VILLAGE REVIEW BOARD

VILLAGE REVIEW BOARD AGENDA

PROJECT NAME: New Condominium Building

CASE NUMBER: VRB 20-006

East and North Elevations
 New 6 Unit Building
 Scale as Noted
 Date: May 27, 2020

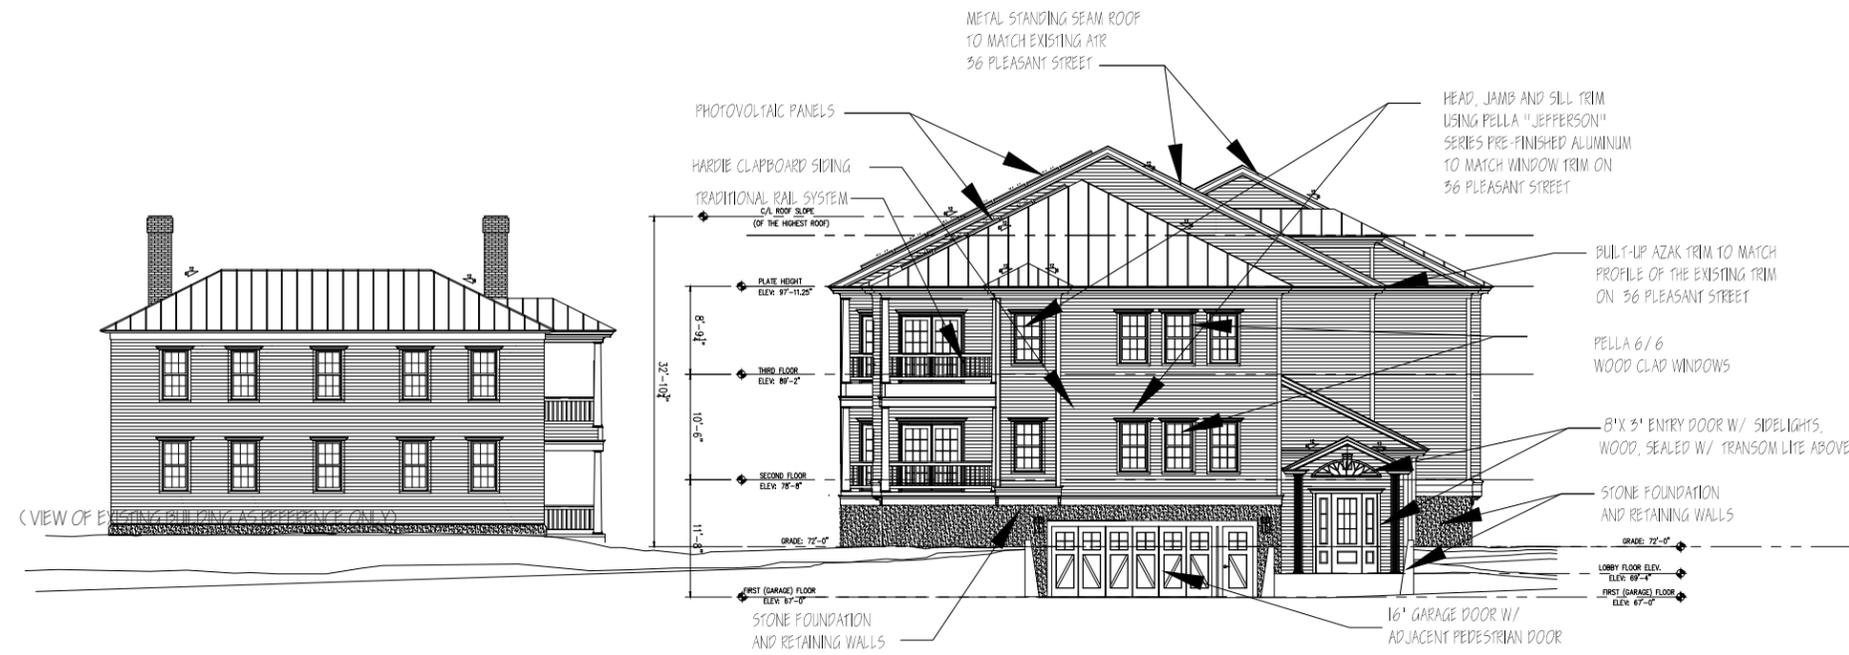
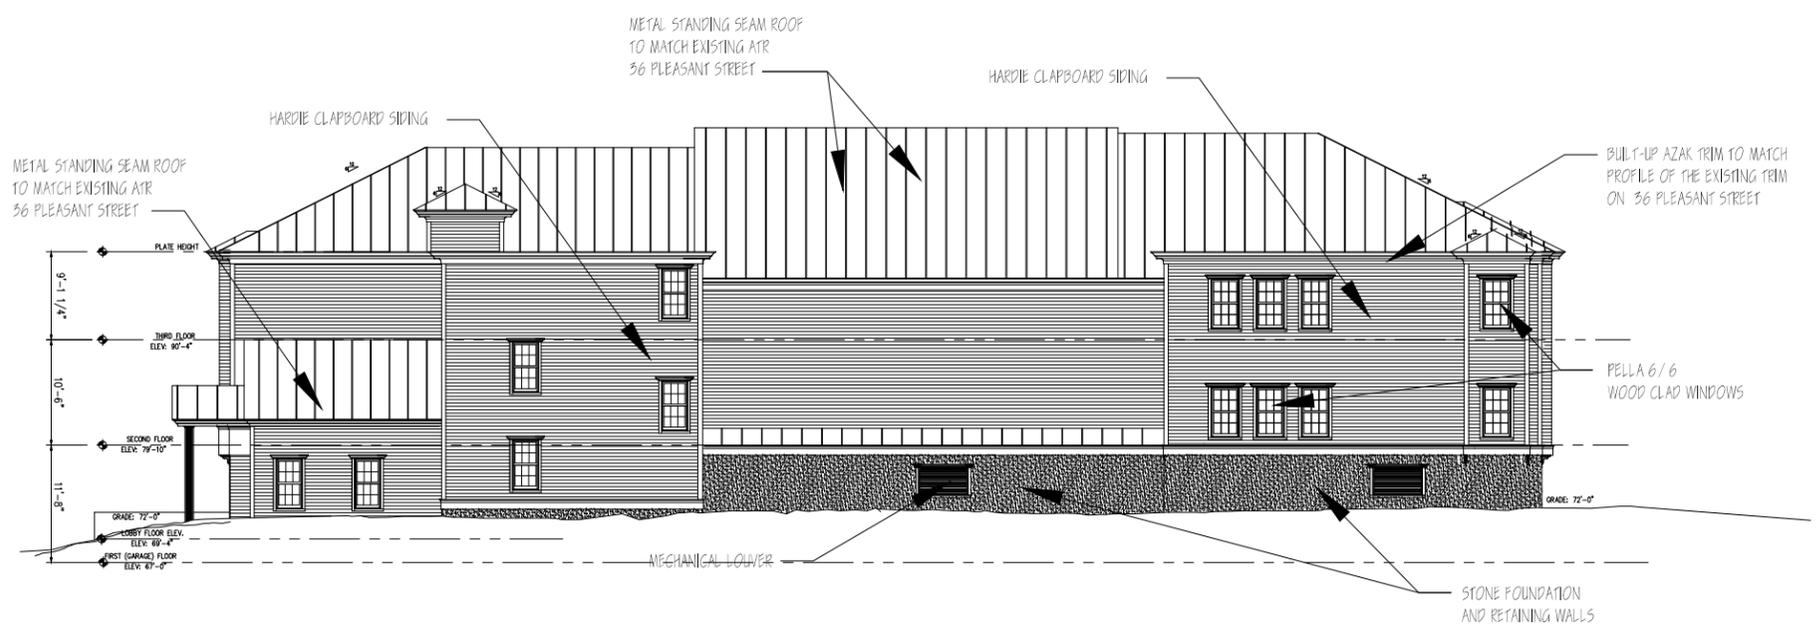
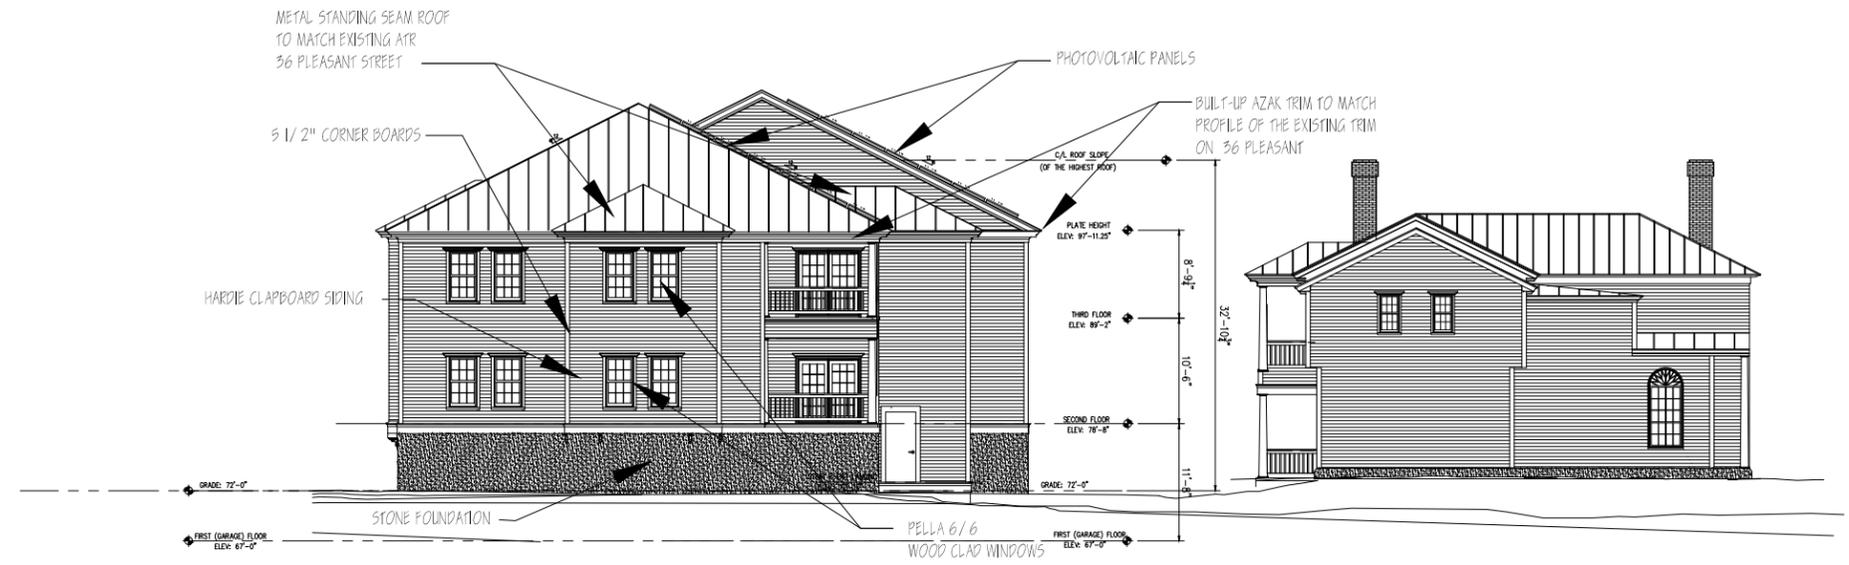
We were surprised to learn at the end of the Planning Board meeting on 5/26 that the overall roof height ordinance does not measure a roof from its highest point. In fact it is measured as the average between the ridge line and the eaves. This means that even with the improvements that have been made, the overall height as seen from the front of the building on Union St remains much taller than 35 ft. Consider that even though the vertical distance between point A and B on the renderings below adhere to the town ordinances on new construction building height in this development zone, the actual visible height as seen from Union St (point C to D) remains substantially greater. As this is the main view of the building, and the obvious front of the building (where the front entrance way is) it makes this view of the building larger than its 'official' 32' 10" height.

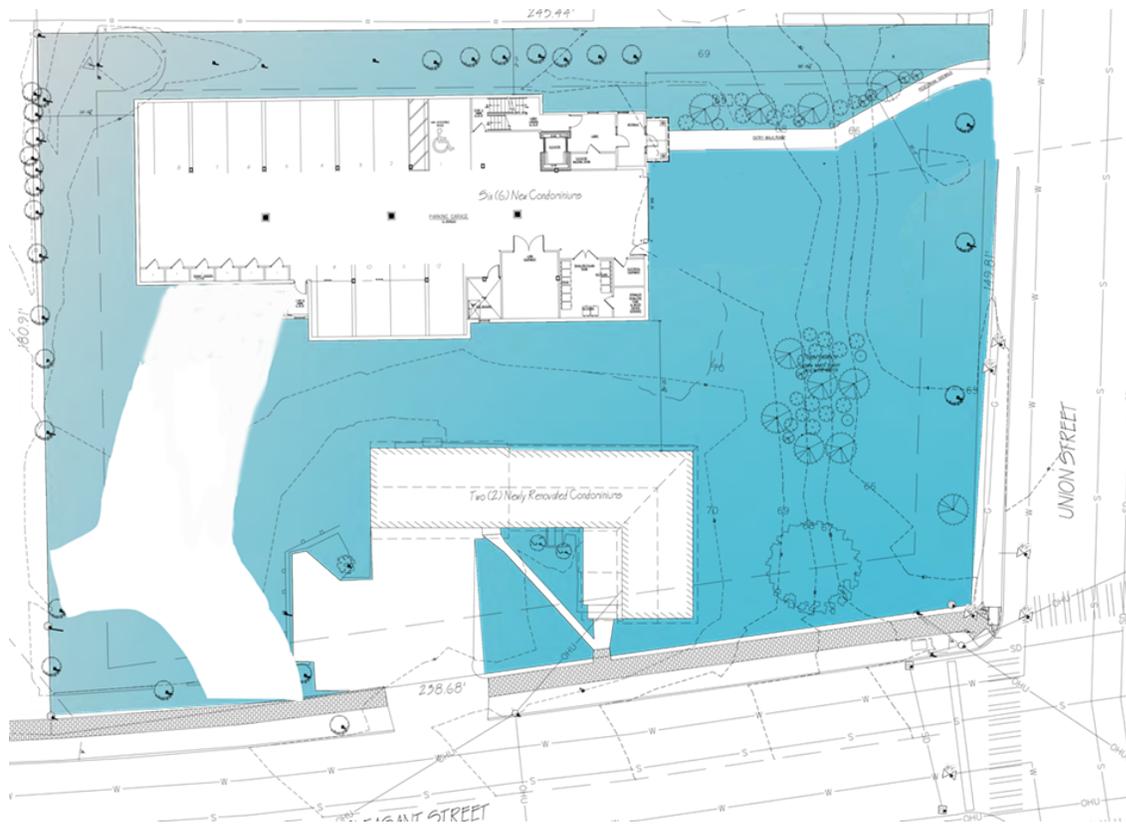
Another question we still have pertains to the placement the driveway. At several meetings, different parties have questioned why the driveway to the condominiums could not come in from Pleasant St. instead of Union St. The primary response has been that the building would have to be turned 180° to achieve this. However, we have pointed out that the pedestrian entrance could remain on Union St, whilst moving the driveway and garage entrance to the Pleasant St side (south elevation). While we are obviously neither architects nor engineers (as evidenced the annotations we have made to Steve's drawings), affecting this change seems to solve many existing issues at once.

With regards to the bulk of the development, having the driveway enter underneath the building at its NW side would make its eastern frontage visually more compatible with surrounding buildings (with the garage entrance no longer there). Compare the top sketch without the garage to the bottom one below to see this effect.

Putting the driveway on Pleasant St. next to the existing driveway would also resolve ongoing concerns about the proximity to the intersection, traffic congestion, and disruption of on-street parking on Union St. It would also achieve VRB guideline #5 as it pertains to the popular pedestrian route along Union St.:

This change would additionally preserve the green space on Union St., both for pedestrians and for the tenants of the condominium. The current design makes the proposed green space that abuts Pleasant Street functionally inaccessible to the condominium tenants. Finally, shifting the driveway would even improve the safety of the garage for its tenants, situating the parking spaces directly adjacent to the garage door, rather than requiring cars to travel through "people space" to park. See figure below for a very rough sketch of what we imagine such a layout could look like.
